Dundee Cycling - Gripes

Area Dundee city centre (waterfront to Marketgait ring road)
 Date of survey 12 Mar 2017
 Status 20 Mar 2017 - version 1.0 complete

Figure 17-6 Start of an advisory contra-flow cycle lane without a traffic island

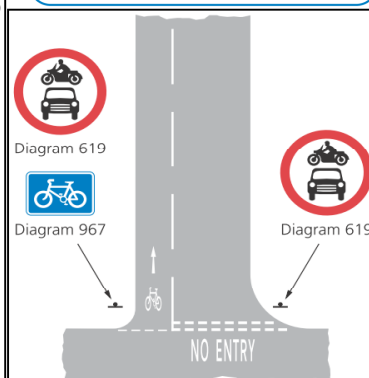
17.27 Figure 17-6 shows the start of an advisory contra-flow lane where it is not possible to provide a traffic island. This arrangement is not suitable for a mandatory contra-flow cycle lane. "No entry" signs to diagram 616 are not used because the absence of segregation would mean that they would apply to cyclists also. Direction 21(2) prohibits the use of the "Except cycles" plate with diagram 616, the main purpose of which is to protect the exit from a one-way road. "No entry" is a safety-critical sign which is very well respected. The only exception permitted is for contra-flow bus lanes; to extend this to cycles would risk undermining public respect for the sign, as to indicate that the road was not in fact one way only would invite contravention. Two "no motor vehicles" signs to diagram 619, without exception plates, are therefore used instead, as they do not prohibit pedal cycles. They should have a diameter of at least 750 mm, as drivers would be at risk if they were not seen. These signs may be supplemented by the NO ENTRY road marking to diagram 1046, in the position shown in figure 17-6; it must not encroach on the area where cyclists enter the contra-flow lane. The Directions do not prevent the NO ENTRY marking from being used on its own, i.e. it does not have to be used in conjunction with the sign to diagram 616. On the left hand side of the road, a sign to diagram 967 should be provided to indicate the cycle facility. Two sizes are prescribed; the smaller size should be adequate.
